10 December 2020
Ref 19516

SSD-10444
PROPOSED PRESCHOOL & PRIMARY SCHOOL
1 ROSEMEAD ROAD, HORNSBY
SITE ACCESS & DRIVER VISIBILITY MATTERS

FIGURE 3.3 MINIMUM SIGHT LINES FOR PEDESTRIAN SAFETY

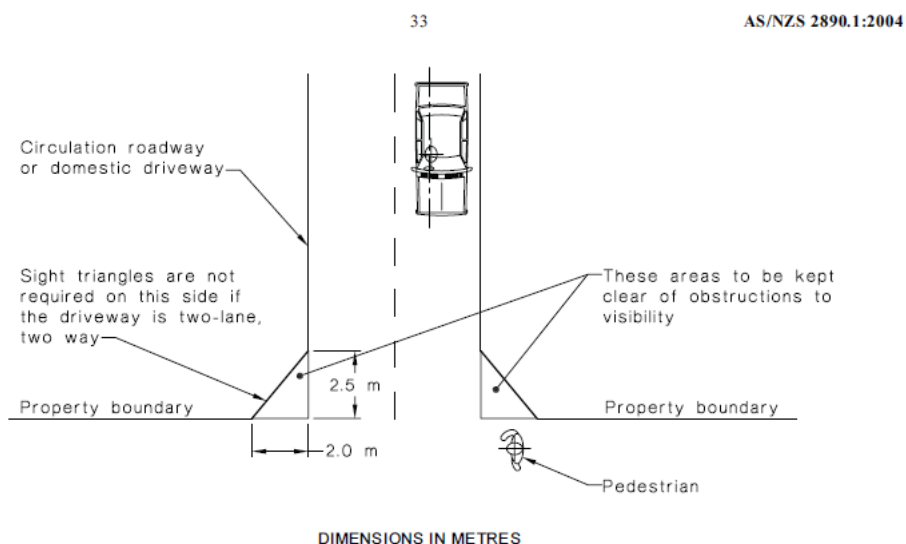
With respect to the pedestrian sight triangle at the site’s proposed exit driveway onto Rosemead Road, as per the AS2890.1:2004 extract below, it is noted that the front fence treatment is a timber paling fence, approximately 1m high, as per the architectural plan extract below.

Accordingly, the proposed front fence treatment will allow sufficient intervisibility between drivers exiting the site and pedestrians walking along the frontage footpath.
